DEVELOPMENT ASSESSMENT REPORT	
Application No.	DA/2023/0257
Address	6 Punch Street BALMAIN 2041
Proposal	Ground, first and second floor alterations and additions to existing dwelling
Date of Lodgement	13 April 2023
Applicant	Andrew Ireland
Owner	Mr Barry S Jackson
Number of Submissions	3
Value of works	\$211,500.00
Reason for determination at Planning Panel	Section 4.6 variation exceeds 10% (FSR)
Main Issues	Development standard breach (FSR and Site Coverage) DCP non-compliances Neighbouring objections
Recommendation	Approved with Conditions
Attachment A	Recommended conditions of consent
Attachment B	Plans of proposed development
Attachment C	Section 4.6 Exception to Development Standards
Attachment D	Heritage Impact Statement

1. Executive Summary

Figure 5: Snip of amended bedroom 2 plan, in accordance with recommended design changes

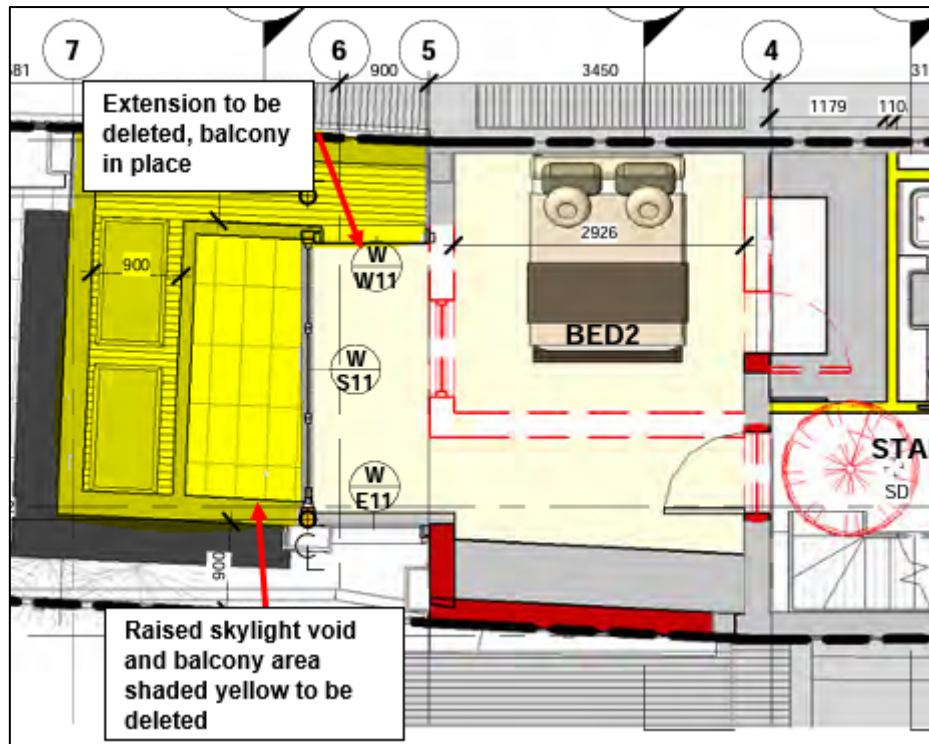
Should the recommended design change to bedroom 2 be adopted, the resultant layout of bedroom 2 will include internal dimensions of 2.926m by 3.8m - 4m, with a walk in robe and balcony with dimensions of 1.2m by 2m (see figure 3 below). This is considered sufficient for the intended use, particularly given the constrained nature of the site.
